[Informal Document No. GRRF-63-32-Rev.1](#)
(63rd GRRF, 4-8 February 2008
agenda item 10(b))

Alignment of Regulations Nos. 13 and 13-H

Proposal for amendments to Regulation No. 13-H

Submitted by the expert from the European Commission (EC)

[Annex 2

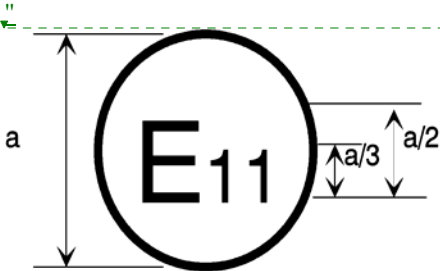
Amend model 'A' and the accompanying text as follows:

The above approval mark..... in its original form. The additional marking 'ESC' indicates that the vehicle meets the electronic stability control requirements of Annex 9 to this Regulation.
